TB CARE I

TECHNICAL ASSISTANCE FOR RENOVATION OF MDR-TB WARD AT  
MULAGO HOSPITAL

ENVIRONMENTAL/ENGINEERING REPORT

SPUTUM BOOTH

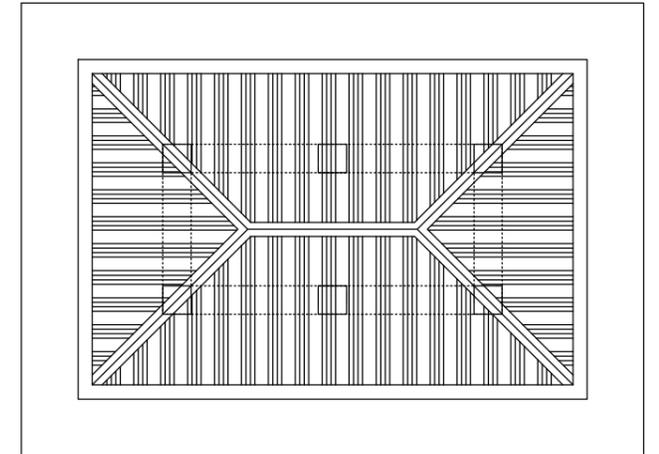
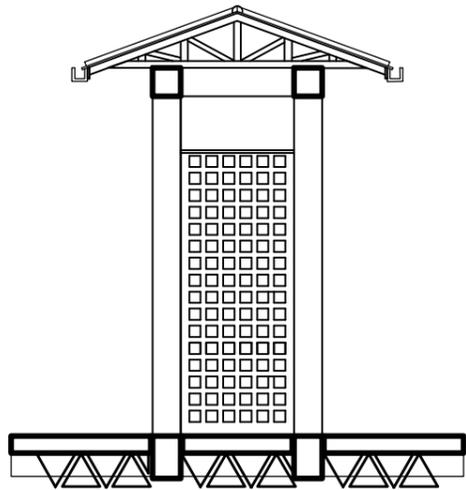
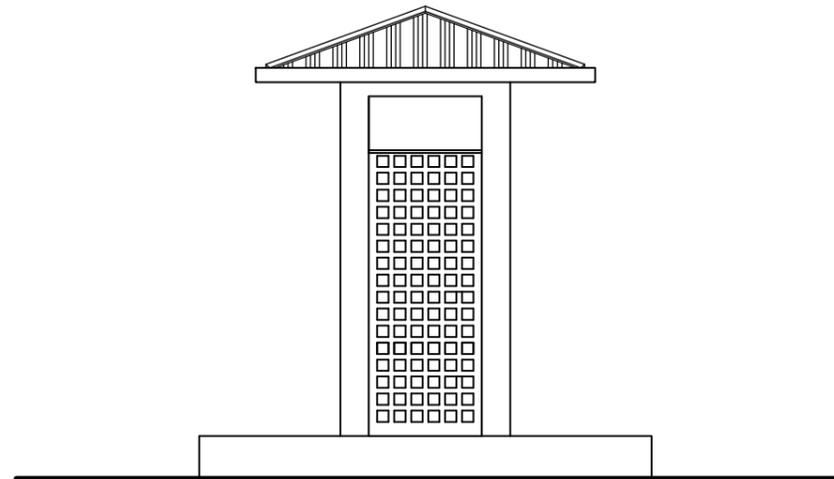
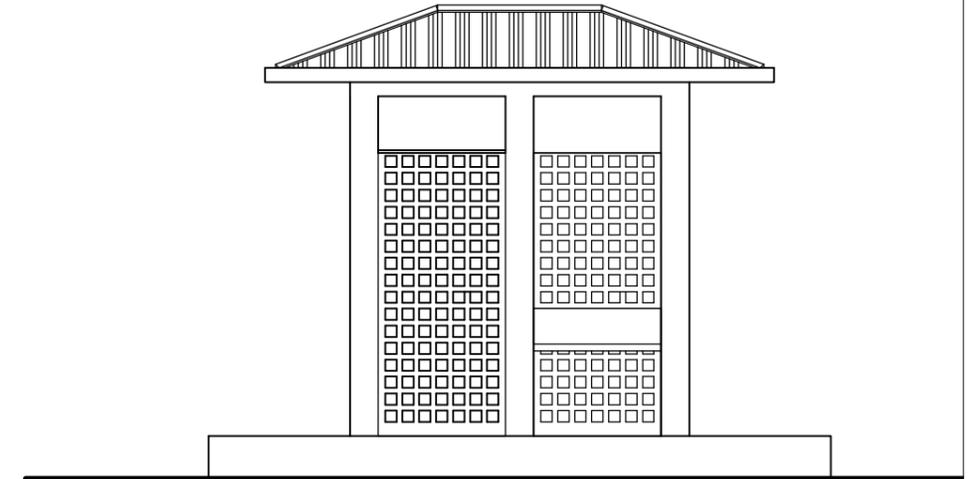
- Providing new structures of relatives' sheds and sputum booth. Sample sputum booth is presented. The sputum booth should be placed at minimum of 6m distance from existing structures and such location is suggested.
